**Development Permit Panel  
Electronic Meeting**

**1. DEVELOPMENT PERMIT 17-790086**  
(REDMS No. 6165570)

PROPERTY LOCATION: 9291 and 9311/9331 No. 2 Road

*That a Development Permit be issued which would permit the construction of 12 townhouse units and one secondary suite at 9291 and 9311/9331 No. 2 Road on a site zoned "Low Density Townhouses (RTL4)" with vehicle access provided via 9211 No. 2 Road.*

2 NORTH ELEVATION  
SCALE : 3/16" = 1'-0"

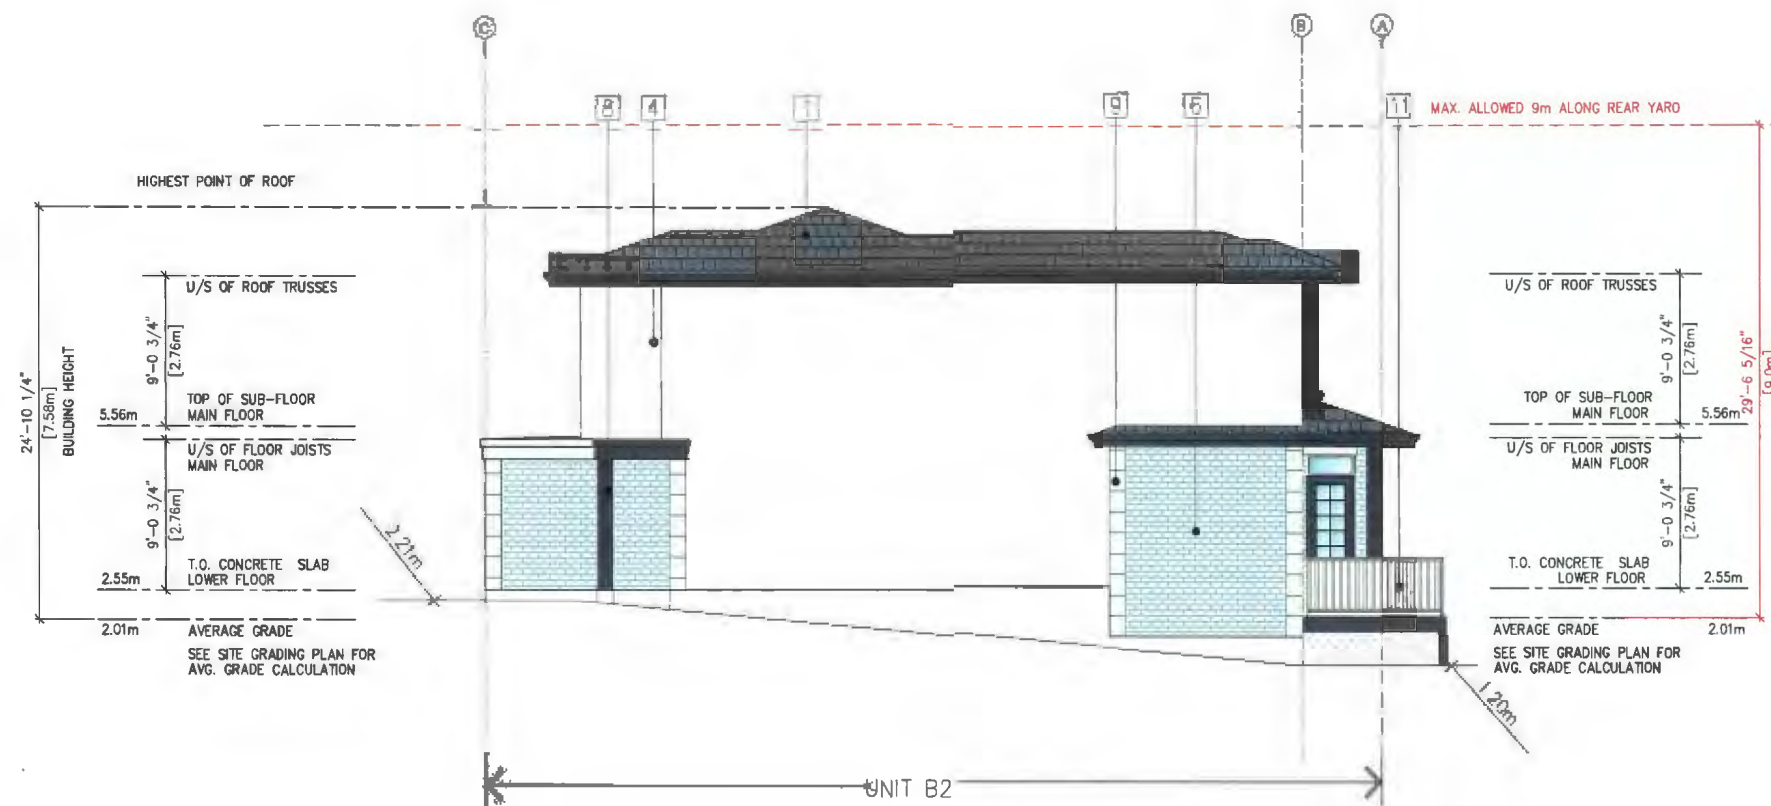
- consider installing additional glazing on the north elevation of Building 1 to provide passive surveillance opportunity over the vehicle entrance to the development and the visitor parking area;

*North elevation of building 1 has been revised with overall massing being reduced by using a lower slope for the roofs and addition of another window on this side to improve passive surveillance opportunity over the vehicular entrance to the development and the visitor parking area.*
